□
PRODUCT CHANGE NOTICE
PCN Form (D4-E000-73)

PCN#10-022-1

TCBT-2R5G+, TCBT-6G+, TCCH-80+

GU1604

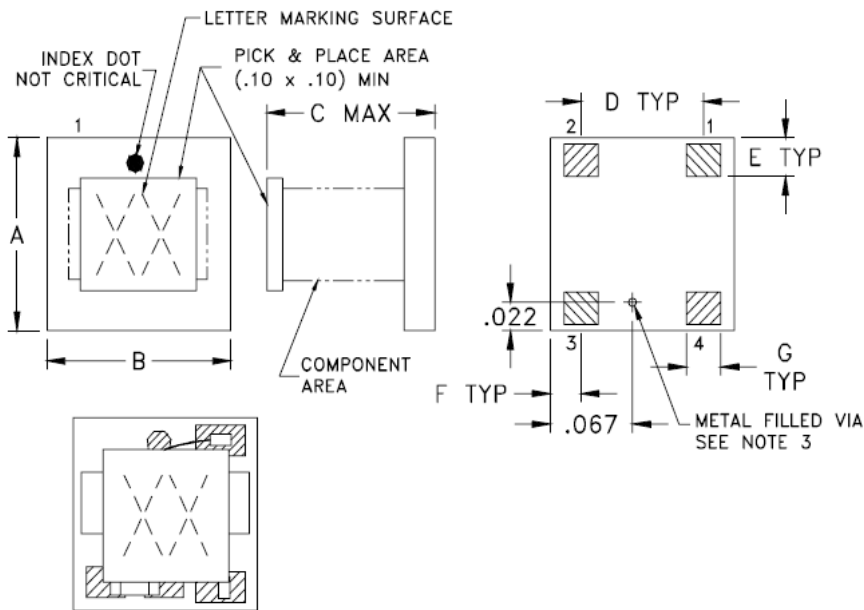
Addition of Tophat TM (flat 'lid') to top-side of the core to enhance customer ability to handle in automated processing and to provide a surface for device marking

- No change in overall dimensions specification
- No change in fit , function or part number
- Minor change in form (device appearance and added model specific marking)
